AUSTIN ROVER

BULLETIN
MONTEGO TECHNICAL

Item 10

COOLANT LEAK FROM RADIATOR
 (Issue 2 to correct part nos.)

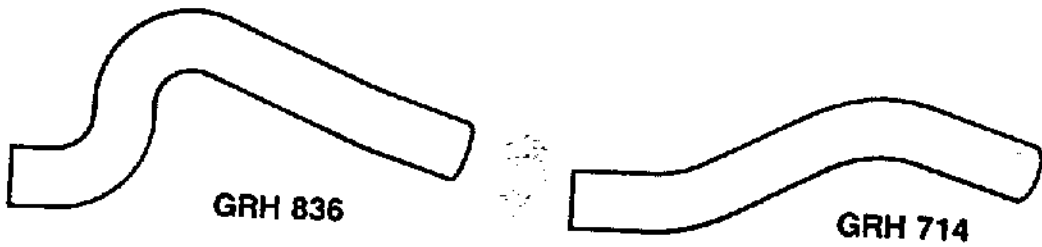
Where a customer complains, the following action is suggested as an interim "fix" pending the introduction of a modified duct.

- 1 Disconnect battery and remove wiper motor plenum cover.
- 2 Remove instrument pack and speedometer cable.
- 3 Detach foam material from upper surface of right

hand face level vent adjacent to speedometer cable.

- 4 With a pad saw or a heavy duty craft knife, cut a "V" section approximately 32 mm wide and 15 mm deep from the right hand face level vent duct, as shown in illustration. Ensure that any swarf or small particles are removed .
- 5 Cover cut area of duct with black waterproof tape, forming a suitable depression to provide clearance for cable.
- 6 Check position of wiring harness to ensure that it will not foul the cable on re-assembly. Re-position harness if necessary.
- 7 Fit new cable and refit original instrument pack, ensuring that cable is positioned centrally in the cut-out section of the heater duct to avoid fouling. It is necessary to fit a new cable as abnormal wear will have taken place within the cable where it has fouled the duct or the harness.
- 8 Refit wiper motor plenum cover, reconnect battery and road test vehicle.

fig. 10/1

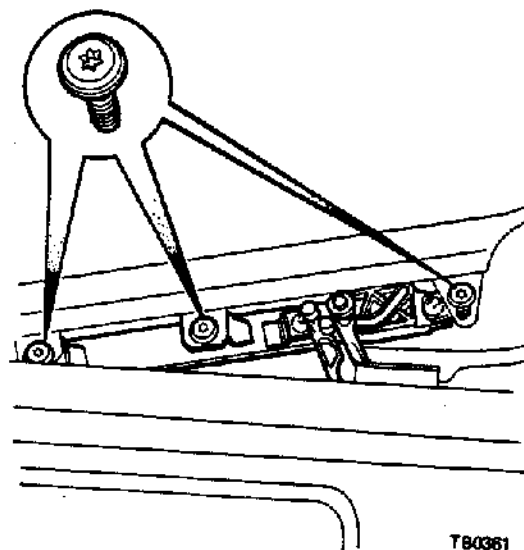
Radiator damaged by engine vibration transmitted via excessively rigid top hose.

A modified hose can be identified as shown (see illustration) and, where this problem is encountered, one should be fitted at the same time as a replacement radiator to avoid recurrence.

More flexible top hose introduced at vin:

model	old part no.	new part no.
Maestro	GRH 705	GRH 835
Maestro van	GRH 714	GRH 838
Montego	GRH 705	GRH 835
